**SUNDRY NOTICES AND REPORTS ON WELLS**

2. Name of Operator  
ConocoPhillips Company

SJ 31-6 Unit #230A

ConocoPhillips requests permission to change in current BOP program:

# BLOWOUT PREVENTER ARRANGEMENT & PROGRAM

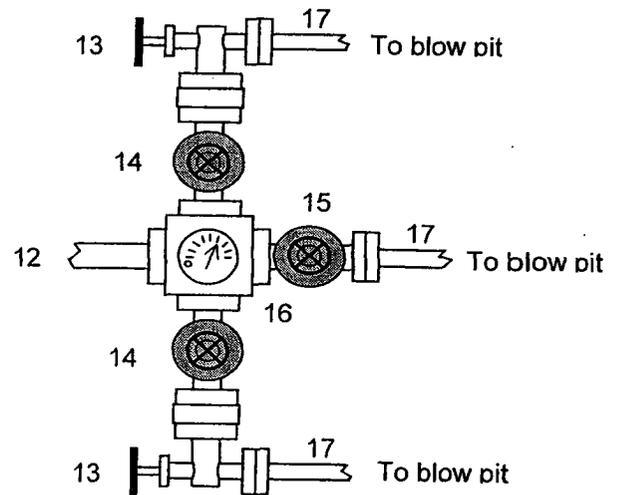
- To specify our BOP program for our cavitation operations
- To request an exception to Onshore Order #2 to allow us to test our BOP and 7" casing (for the cavitation program) to 1800 psi in lieu of Onshore Order #2 requirements

This BOP arrangement and test program is for the cavitation program. The BOP will be installed on the tubing head. The 7" casing will be pressure tested against closed blind rams to 200 psi to 300 psi for 2-3 minutes and to 1800 psi for 30 minutes - this test pressure is 48% of the minimum internal yield strength of 3740 psi for the 7", 20#, J-55, STC casing. The pipe rams and choke manifold will be tested to 200 psi to 300 psi (low pressure test) for 2-3 minutes and to 1800 psi (high pressure test) for 10 minutes - This test will be done with a test plug or possibly without a test plug (ie against casing). If we conduct this test without a test plug we will ensure that we have sufficient drillstring weight in the hole to exceed the upward force generated by the test.

We use a power swivel and air/mist to drill the 6-1/4" hole in our cavitation program. We do not use a kelly. In addition to the equipment in the above diagram the following equipment will comprise the BOP system:

1. String floats will be used inside the drillpipe
2. Stab-in TIW valve for all drillstrings in use
3. Each bleeie line is equipped with a hydraulically controlled valve (HCR valve).
